Date	2014.05.05
	Safety warning! n°2014/01/E2-E2L-A3

Reserve parachute handles for the EVO XC2, SKYPPER, SHAMANE and SHAMANE FR

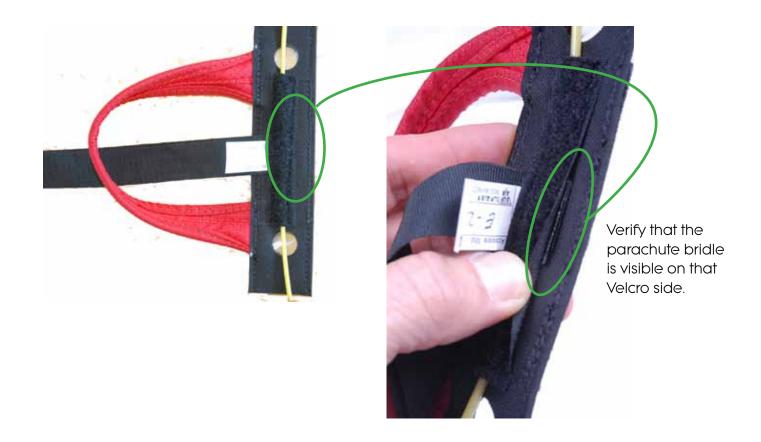
The bridle connecting the handle to the POD must be held in place with the Velcro strip two stitched lines.

A few handles were assembled without the bridle reaching the second stitched line. To check the handle, you must look underneath the Velcro strip and see if it is visible under the stitched line.

If the handle conforms then, reposition it has it initially was.

If the handle does not conform: you must contact your nearest SUPAIR dealer, or SUPAIR representative in your country, or SUPAIR-France directly, at sav@supair.com to proceed with the free of charge reserve parachute handle replacement.
